HI-STORM 100 CERTIFICATE OF COMPLIANCE 72-1014

LICENSE AMENDMENT REQUEST 1014-1

April 25, 2000

Subject: Holtec Proprietary Information

FIGURE 2.1-1
FUEL LOADING REGIONS - MPC-24

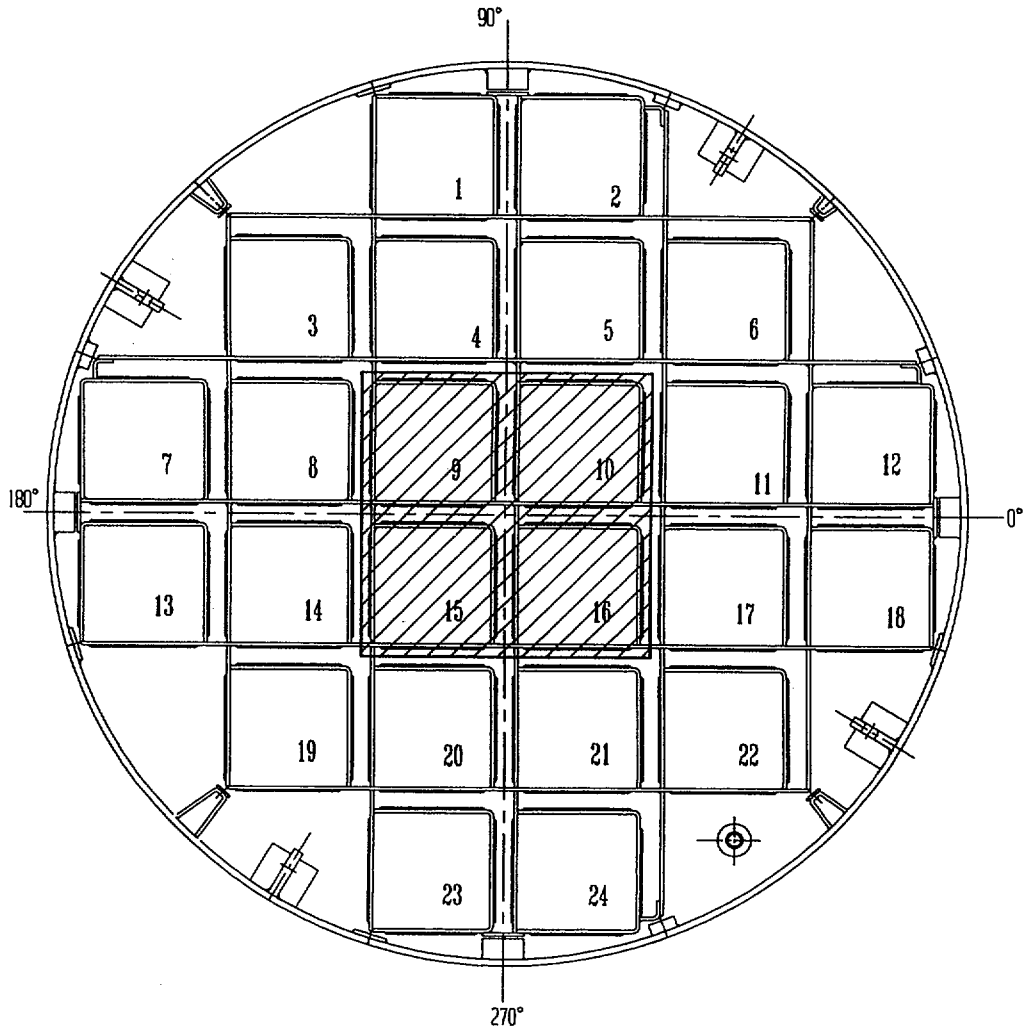
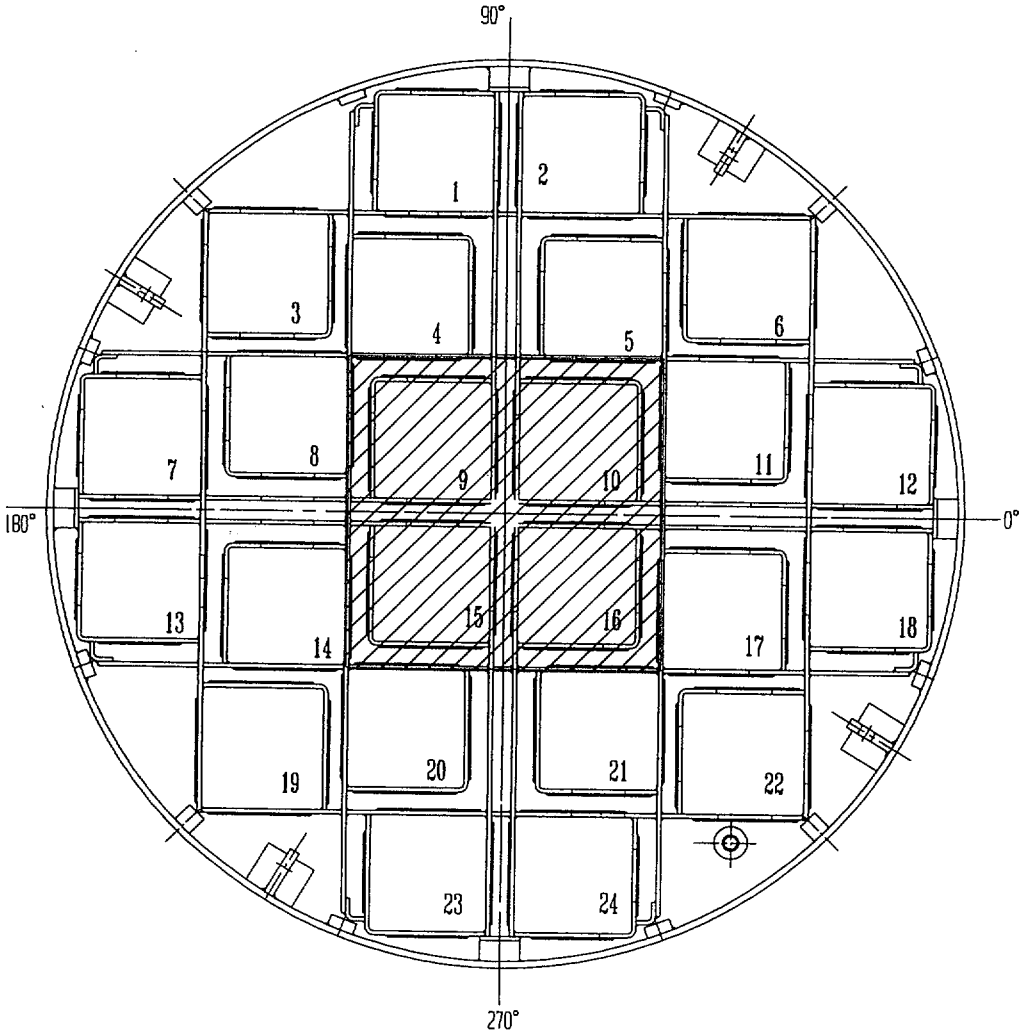
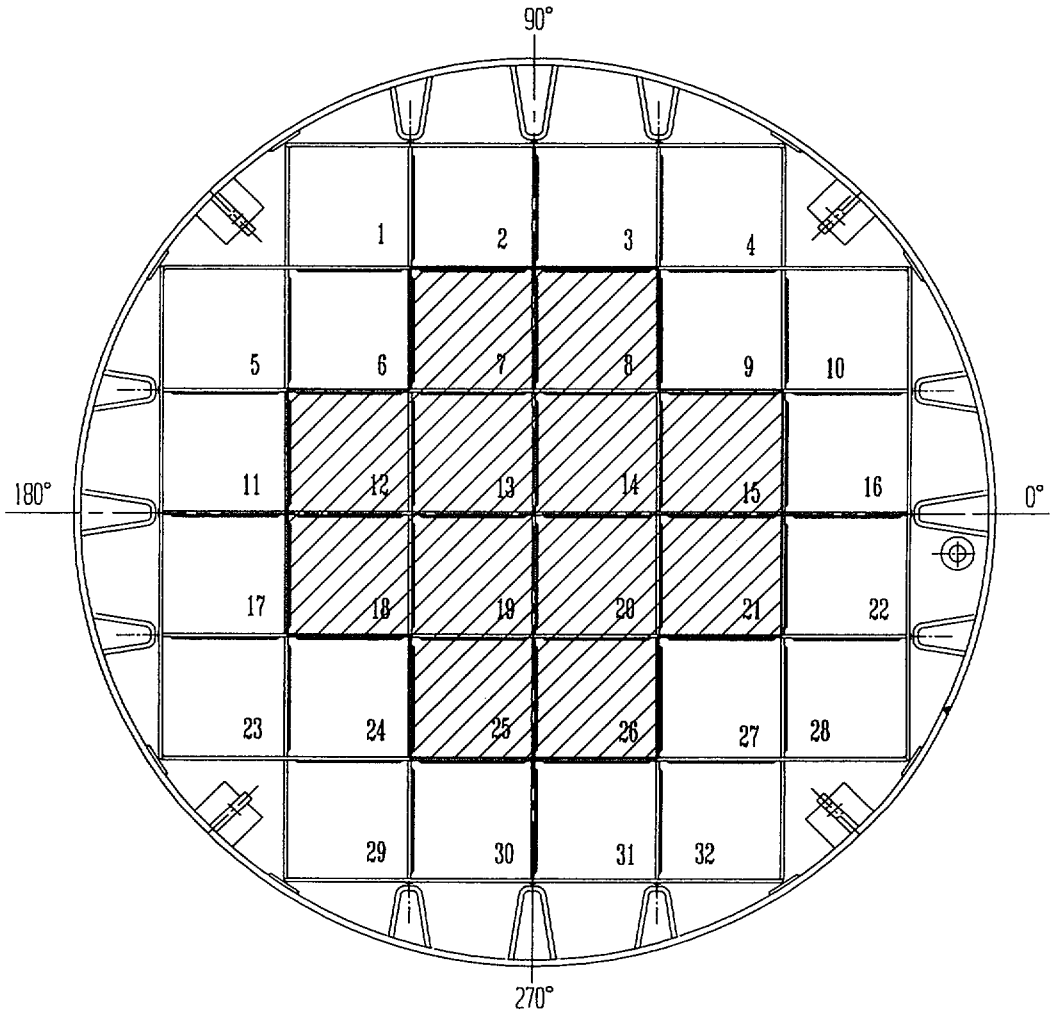
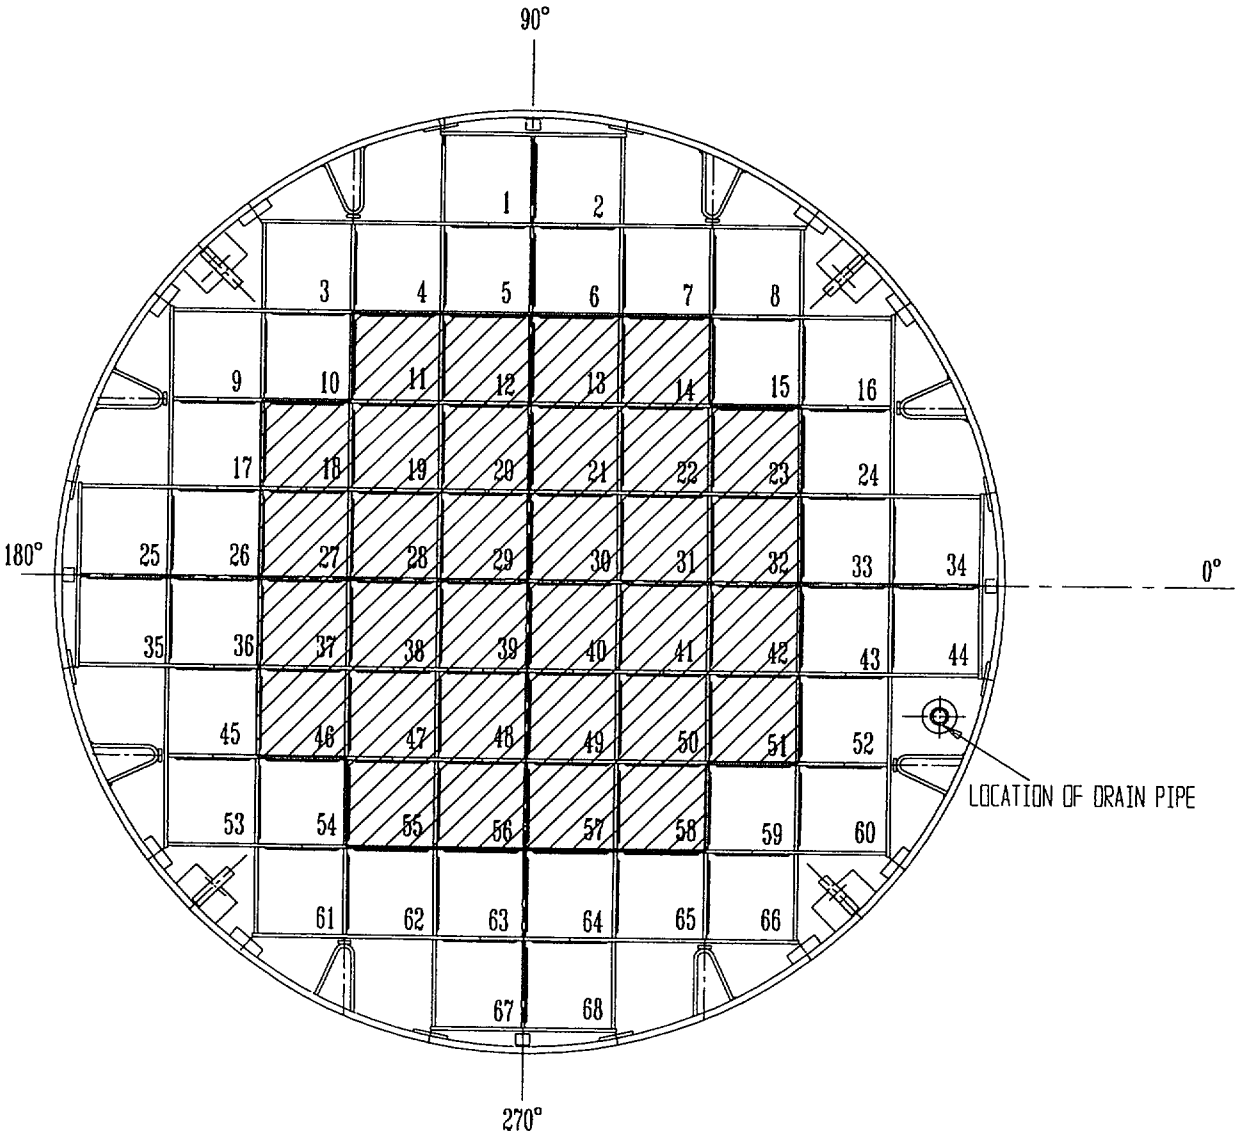
b. New Subsection 2.1.3 and Figures 2.1-1 through 2.1-4 are added to introduce regionalized fuel loading as an option. Specific cooling time, burnup, and decay heat limits for regionalized fuel loading are specified in Tables 2.1-6 and 2.1-7 in the Approved Contents section of Appendix B to the CoC.

FIGURE 1.1.1A; HI-STORM 100S OVERPACK WITH MPC PARTIALLY INSERTED

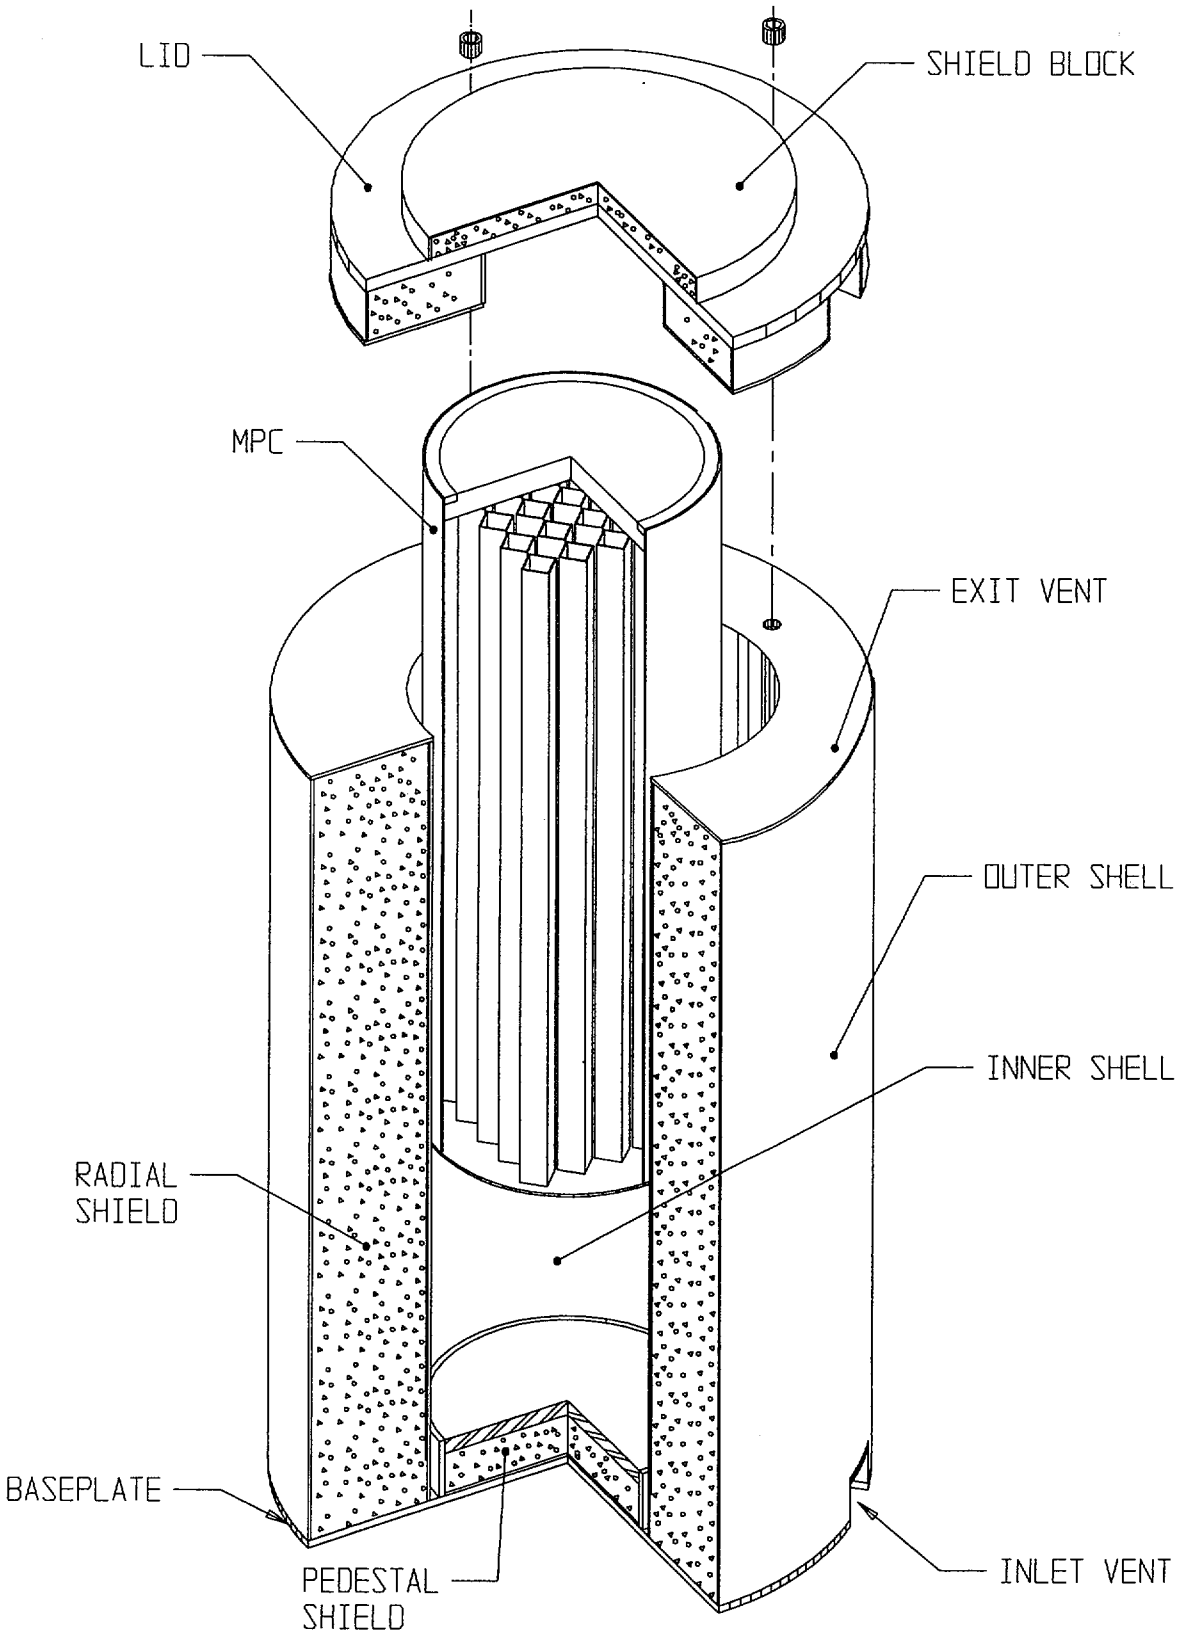
f. New Figures 1.1.1A and 1.1.3A are added to depict the HI-STORM 100S overpack.

FIGURE 1.2.1A; CROSS SECTION VIEW OF THE HI-STORM 100S SYSTEM

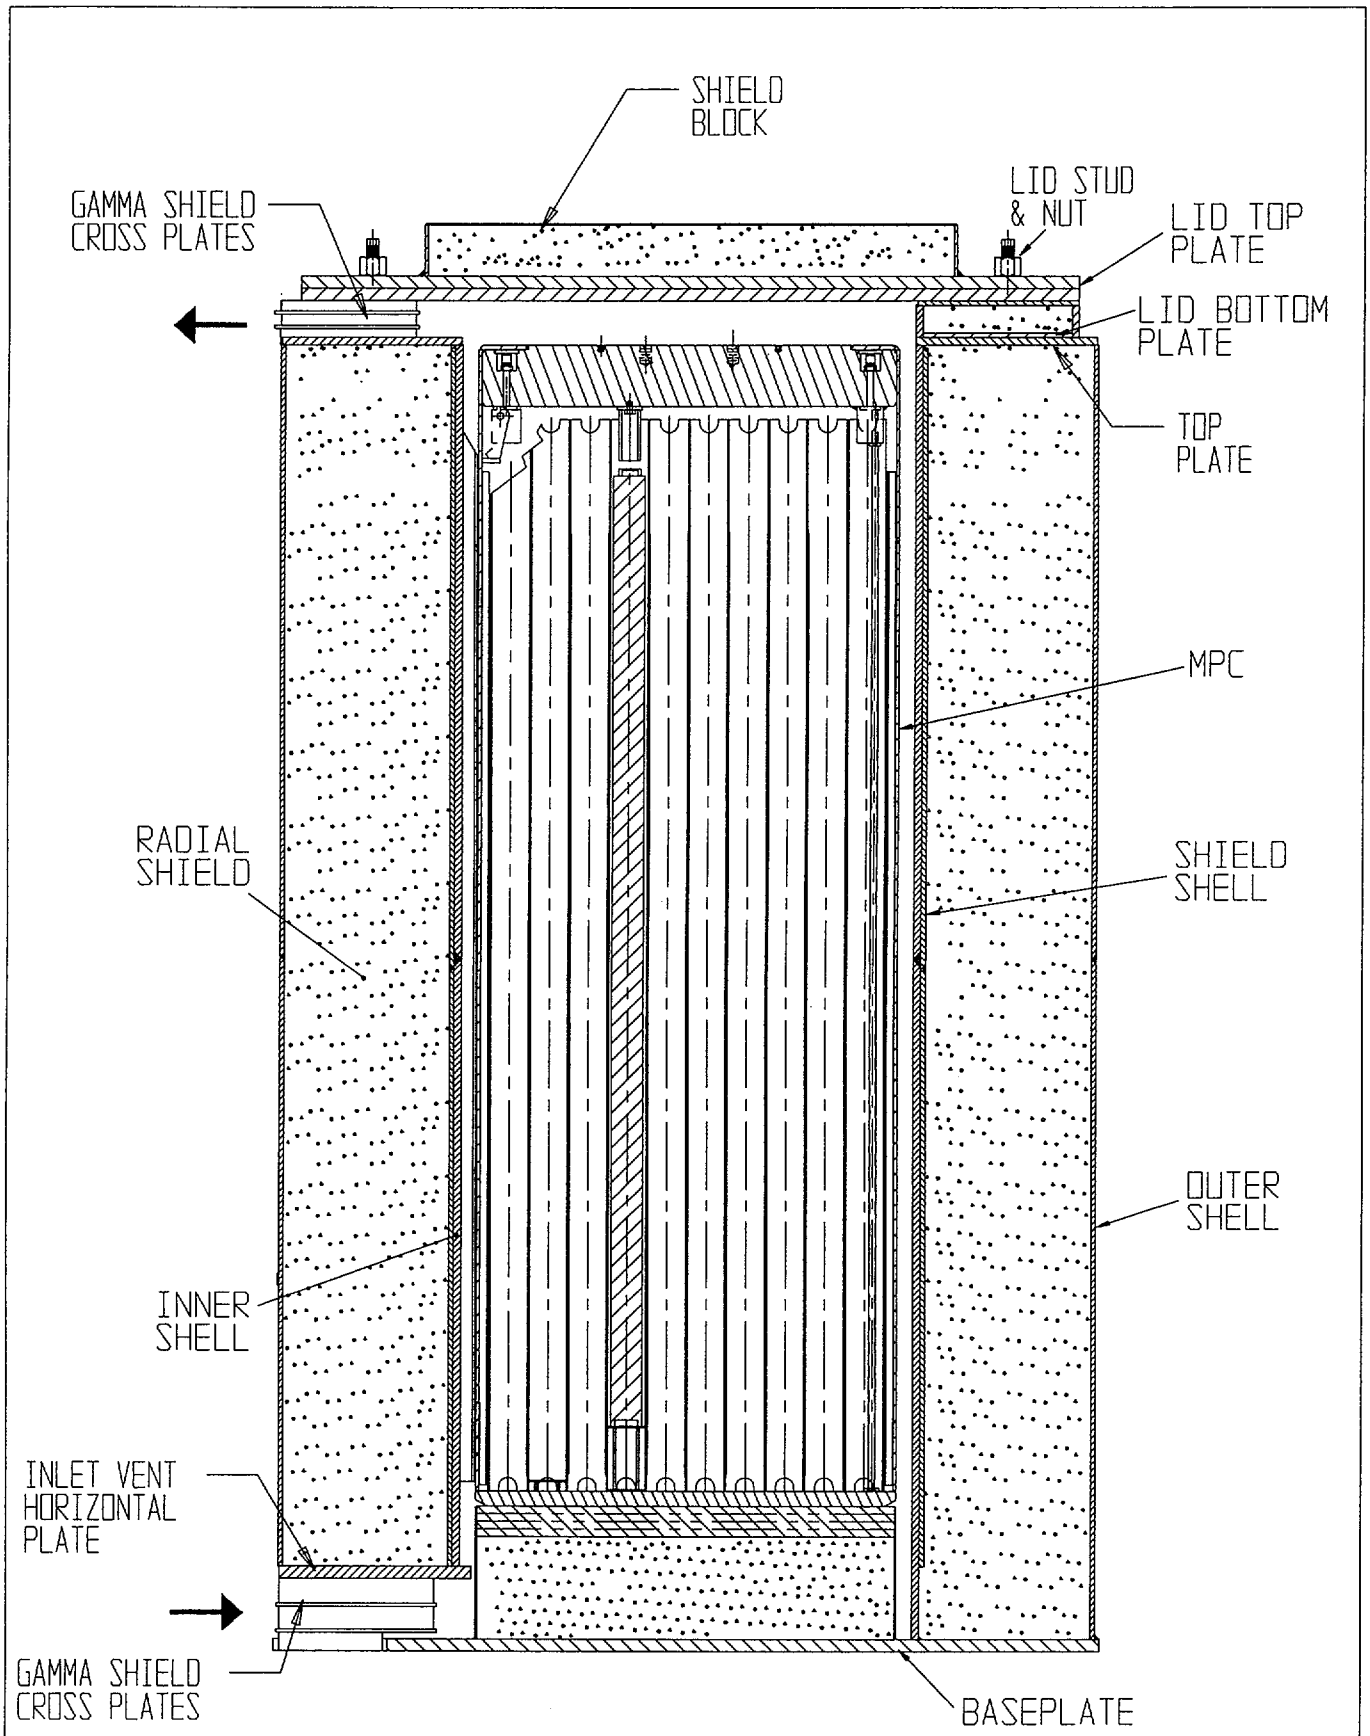
r. Figures 1.2.1A, 1.2.3, 1.2.4A and 1.2.8A are added.

r. Figures 1.2.1A and 1.2.8A are required to show the HI-STORM 100S overpack design. Figure 1.2.3 shows the MPC-32 basket layout and Figure 1.2.4A shows the MPC-24E basket layout.

Figure 2.1.3; PWR Axial Burnup Profile with Normalized Distribution

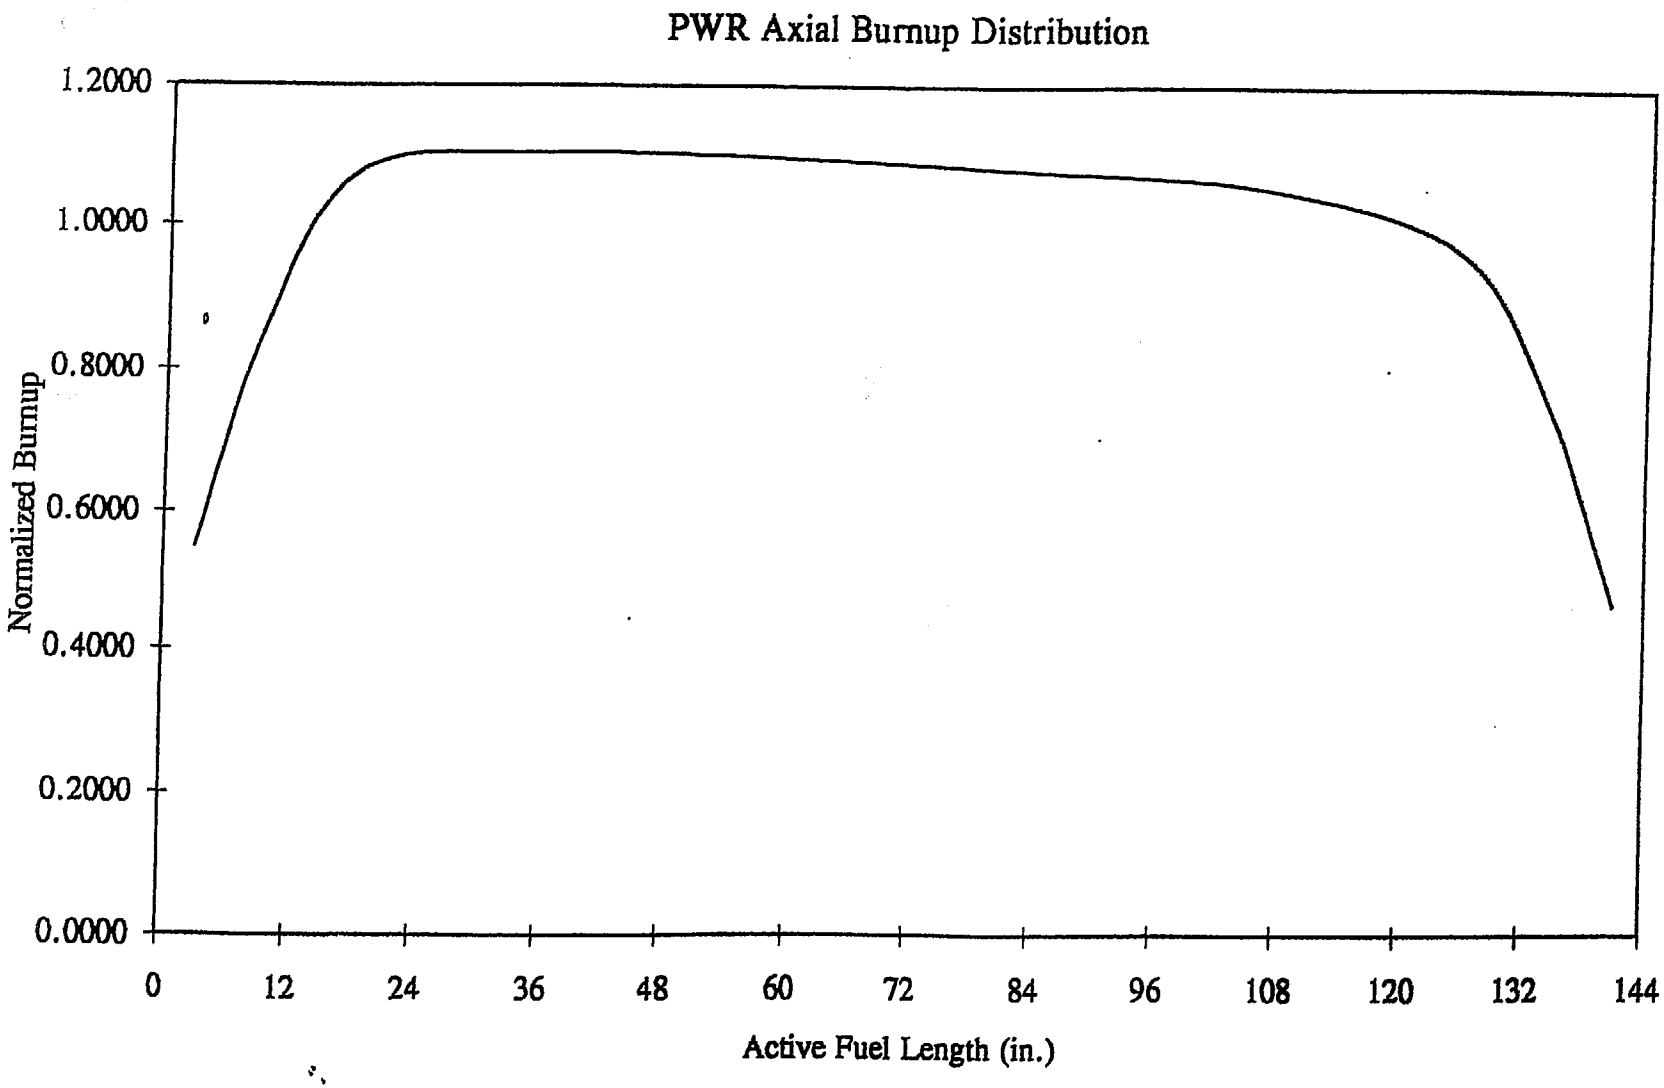
z. Figures 2.1.3 and 2.1.4 are revised to delete the proprietary note in the footer.
